# White Rock Wind Farm

## Modification Application

### MP10\_160 MOD 3

## Environmental Assessment Report

Figure 1.2 WRWF Stage 1 – Indicative Modified Construction Layout

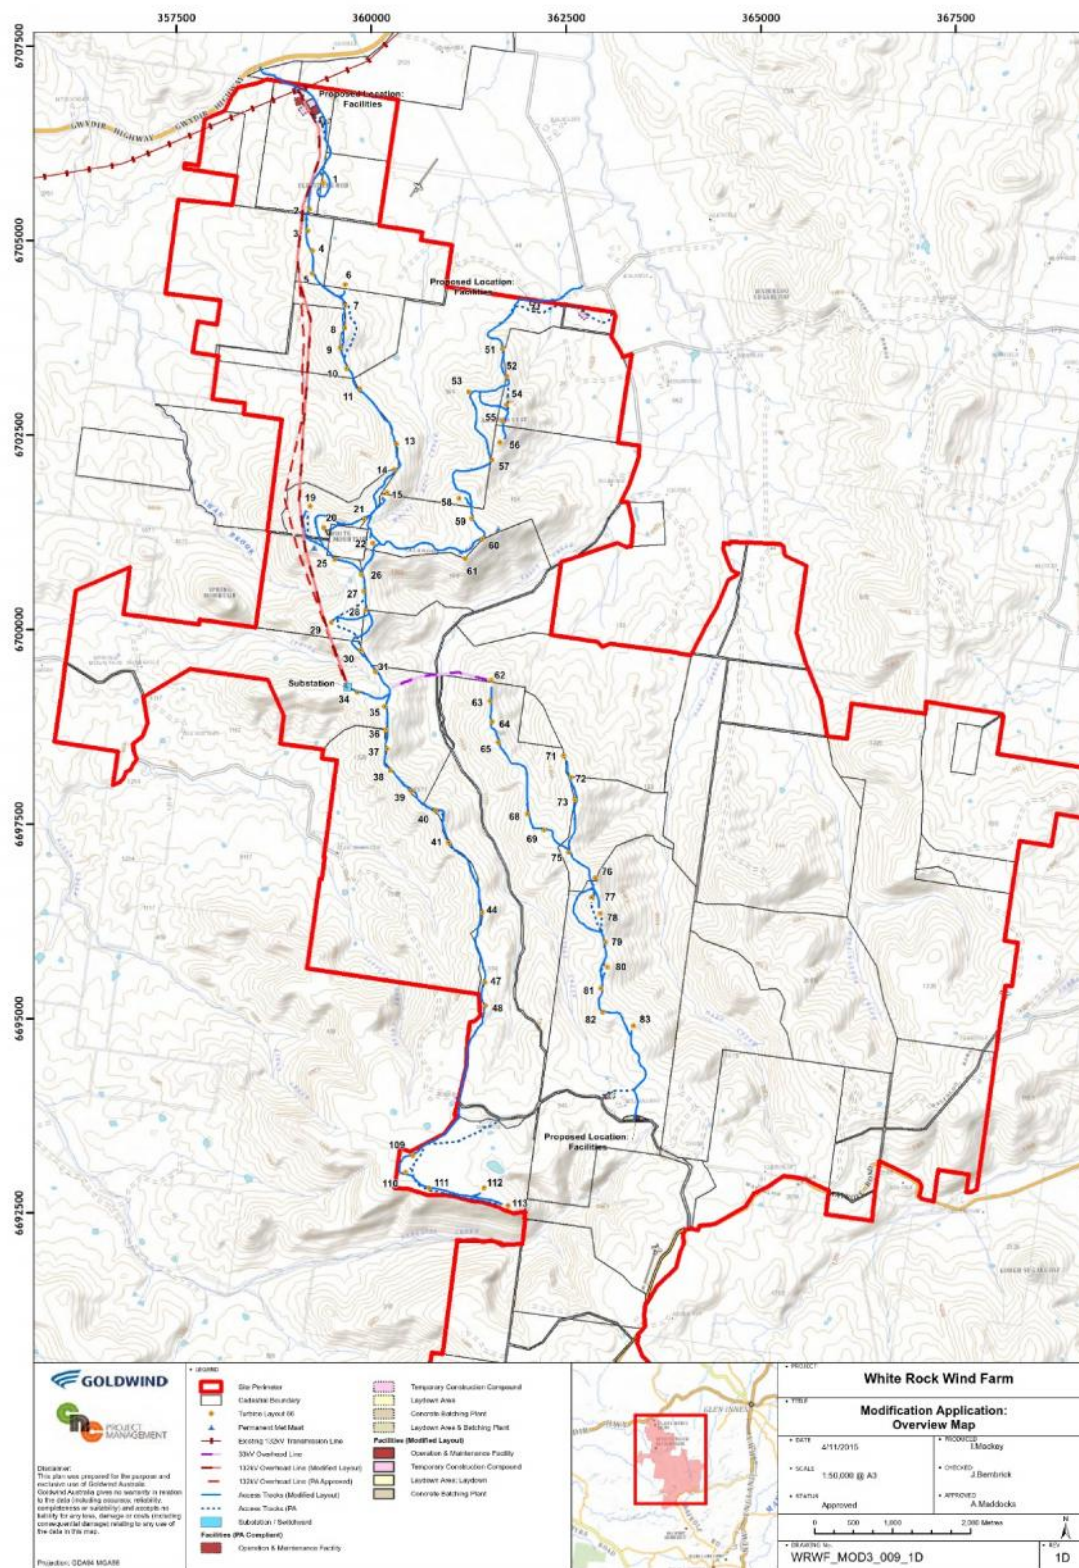
Construction of WRWF Stage 1 is scheduled to start in the first quarter of 2016. The project variations sought as part of this Modification Application relate only to minor adjustments to the layout for Stage 1. The modifications involve movement of project components by more than the 100 metre micro-siting allowance permitted by the Project Approval.

**Figure 4.3**

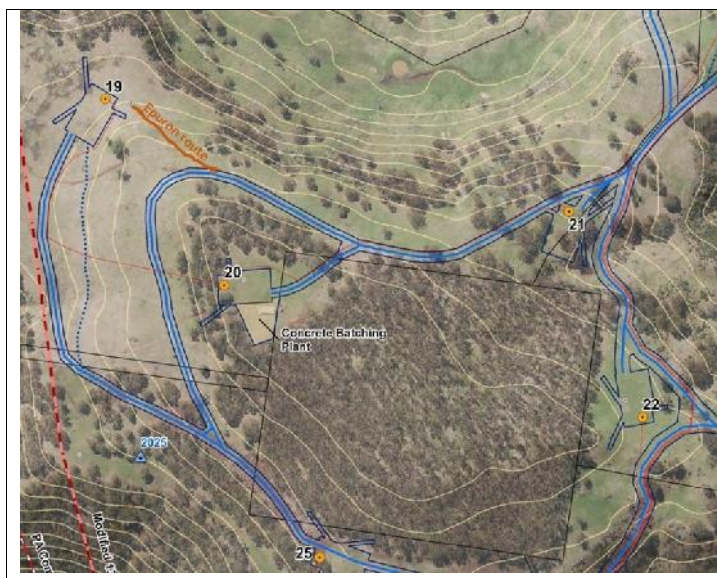
An alternative access track to Turbine 19 is proposed on the lower part of the slope where it may be concealed behind existing vegetation on its western side (Figure 4.3). The proposed alternative access track alignment would be located in an area of exotic pasture and, neither the approved route, or the alternative route would have impacted conservation significant native vegetation. The land where the alternative track route is located is on a more gentle slope and the alternative route is likely to be more stable. There are no registered Aboriginal sites in this locality.

**Figure 4.4****Access Tracks T29 and T28 to T30**

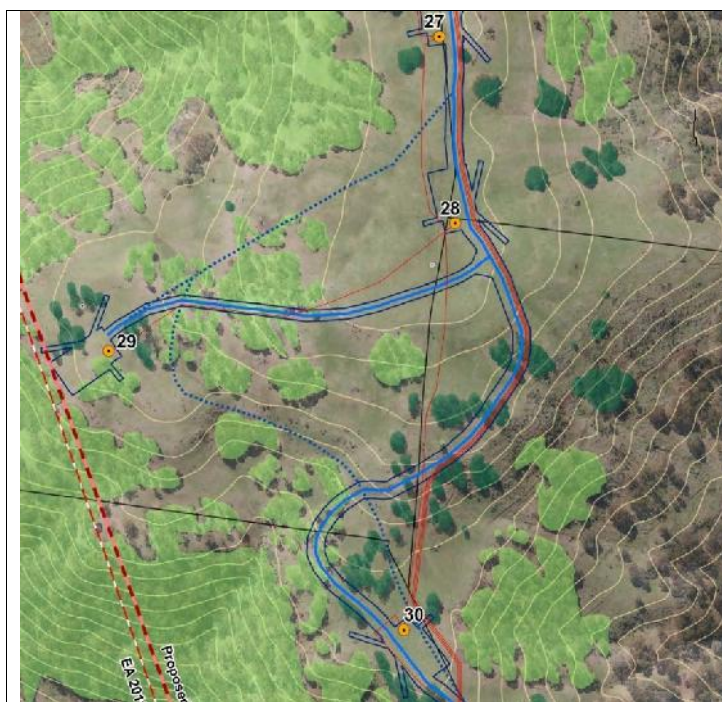
The EA, 2011 showed the access route from south of Turbine 27 direct to Turbine 29. However, review of the locality by the design team has indicated that this direct route is less suitable than an alternative route which follows the ridgeline from Turbine 28 to Turbine 29 (Figure 4.4). While it may have appeared that there is a greater impact on vegetation by the alternative route, the vegetation for this route is quite open with an exotic understorey. Plate 3.2 shows the setting for Turbine 29. The alternative route for access to Turbine 29 is unlikely to result in significant increase on native vegetation.

The alternative access track to Turbine 30 has been realigned from the approved route (Figure 4.4). The Epuron EA, 2011 showed the access originating from the access track to Turbine 29 passing through Ribbon Gum - Mountain Gum EEC and descending over 40m down a south facing slope to reach Turbine 30. The steep slope to be negotiated showed signs of seepage and potential to be unstable for access track construction.

**Figure 4.7**

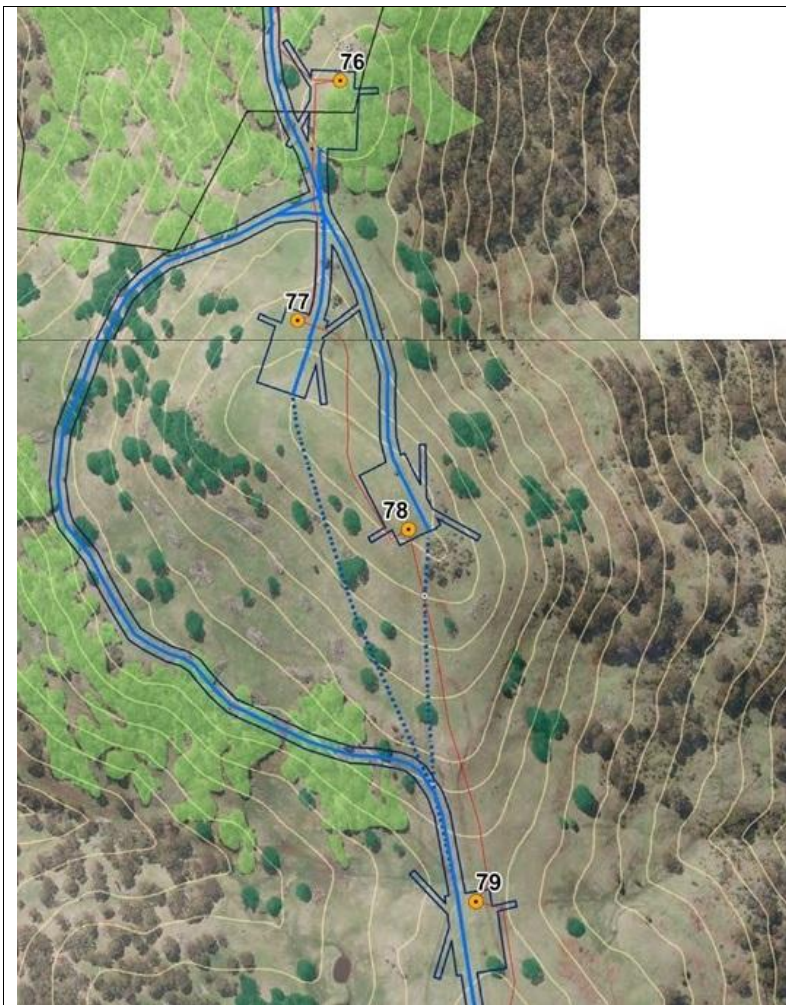
Turbines 76, 77 and 78 are on elevated ridges and require careful planning of the access routes to ensure constructability and avoid vegetation impacts. The access routes shown in Epuron EA, 2011, show two steep access routes to Turbine 77 and to Turbine 78 that are considered unfeasible for the type of transport vehicles involved. These steep routes are represented by dotted lines in Figure 4.7.

**Figure 4.9**

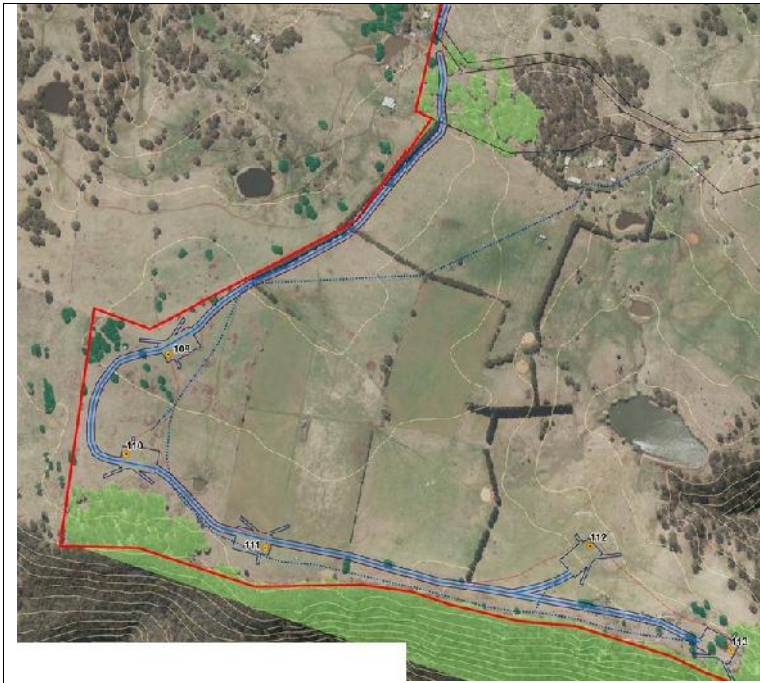
The alternative access track route to Turbine 109 from Kelleys Road is shown in Figure 4.9. The alternative route is about 400m shorter than the approved route. It has been moved away from the route, proposed by Epuron, that went straight past the Melrose residence and nearby stockyards. Apart from the disturbance at the residence, the route had potential to disrupt normal farming activities occurring in the vicinity of the stockyards. The alternative route enters the Melrose property on its western boundary, about 500m west of the location in the application documents. It provides the shortest most direct route from Kelleys Road to Turbine 109.

**Visual impact:** There will be limited visibility of the alternative access track from Kelleys Road or neighbouring properties. The location where the track leaves Kelleys Road will be visible from the road but this was the case either for the approved route or alternative route. A low ridge on the southern side of Kelleys Road will screen views of the bulk of the access track from Kelleys Road. A row of pines along the western property boundary

Figure 4.10

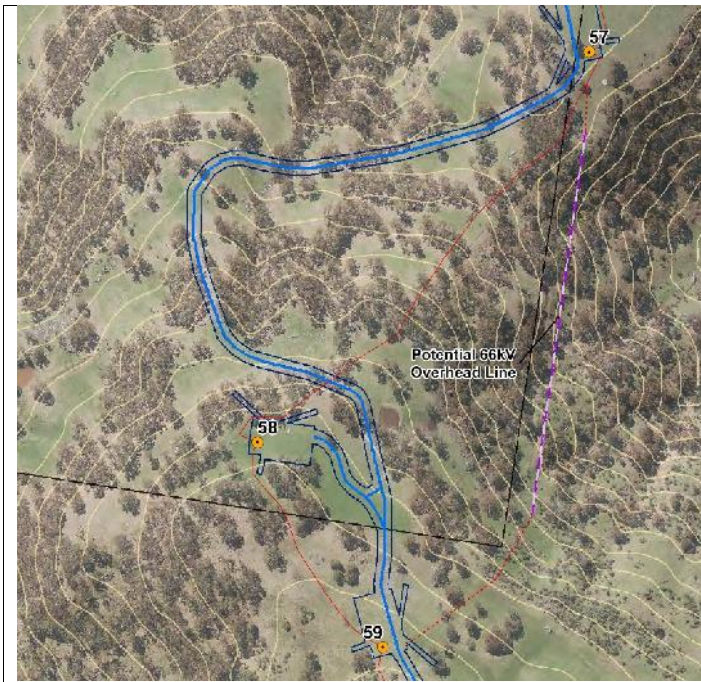
It is proposed that the 0.5km of 33kV overhead line from Turbine 57 to 59 (Figure 4.10, be replaced with a 33kV underground cable that goes directly from Turbine 57 to Turbine 58. The changed connection route is shorter and is also likely to significantly reduce native vegetation impacts due to the greater clearing required for overhead transmission lines compared to the underground cable. The underground cable route can utilise part of the access route west of Turbine 57 and clearings between Turbine 57 and Turbine 58.

**Bushfire risk:** The change from an overhead line to underground cable will reduce risk of bushfire at this location.

The changed from 33kV overhead line 33kV underground cable from Turbine 57 is likely to result in decreased environmental impact.
